Staff Report Presented to the Planning Commission - REVISED

REQUEST: The applicant is requesting to subdivide an approximately 282,704 square foot (6.49 acre) property into 29 residential lots, 1 storm detention lot and associated roadway and utility improvements. The subject property is to the east of 23rd Avenue and west of 27th Avenue and is identified by Linn County Tax Assessor’s Map No. 13S01E32CA Tax Lot 4403. Lot sizes would range in size from 7,206 square feet to 8,626 square feet. All lots would be eligible to be developed with single, family dwellings *and/or duplexes* [SHMC 17.10.020(A and B)]. The subject property is in the Residential Low Density (R-1) Zone.

FILE NUMBER: SD24-01

Sheet **C101**
 SCALE: SEE BARSCALE

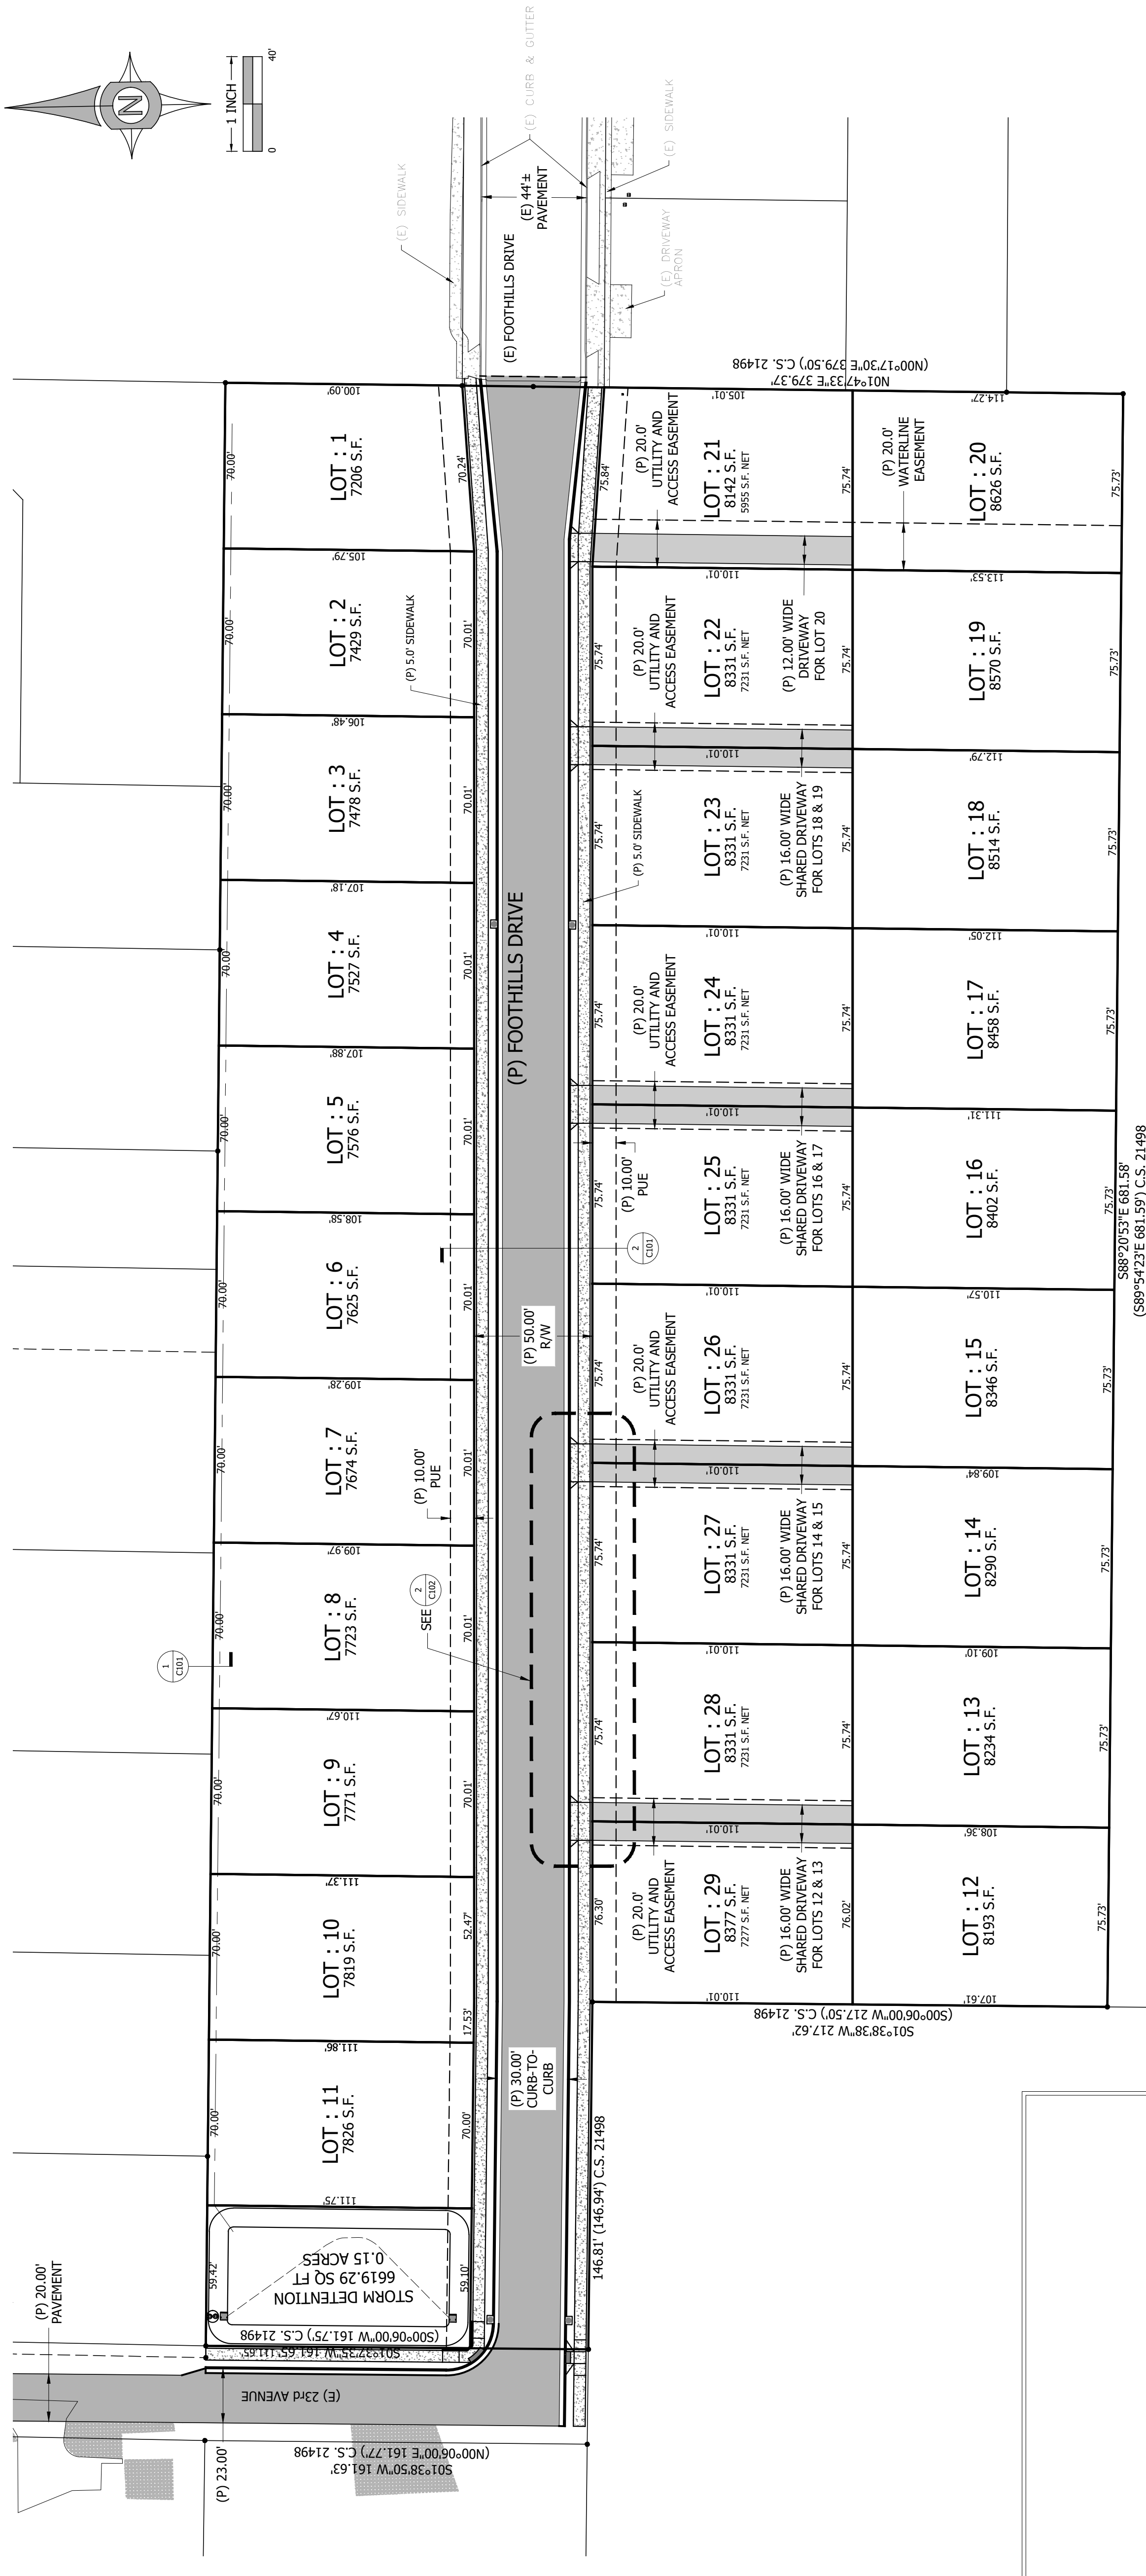
The City of Sweet Home wants to have provision for a waterline easement in the common driveway serving Lot 20 on Lot 21. The easement would be the same size as the proposed shared utility and access easements as noted on the proposed site plan. The easement would run from the south right-of-way line of Foothills Drive to the south line of Lot 20. The City is looking forward 15-20 years to a need for an additional water reservoir in the area, with the adjacent property to the south at the right elevation and location. It has access from Ames Creek Road, so that only a waterline would be connected through the lots. We would likely place a conduit in the ground at the time of construction to feed the future waterline through, without the need for excavation at that future time.

The proposed site plan (Attachment B) shows an access and utility easement serving Lot 20 on Lot 21. The City of Sweet Home recommends a provision for a waterline easement in the common driveway serving Lot 20 on Lot 21. The easement would run from the south ROW line of Foothills Drive to the south line of Lot 20. The City is looking forward 15-20 years to a need for an additional water reservoir in the area, with the adjacent property to the south at the right elevation and location. It has access from Ames Creek Road, so that only a waterline would be connected through the lots. We would likely place a conduit in the ground at the time of construction to feed the future waterline through, without the need for excavation at that future time.

4. The applicant shall provide a *public* waterline easement through Lot 21 in the common driveway that serves Lot 20. The easement would be the same size as the proposed shared utility and access easements as noted on the attached site plan (Attachment B). The easement would run from the south right-of-way line of Foothills Drive to the south line of Lot 20, and shall be shown on the final plat.
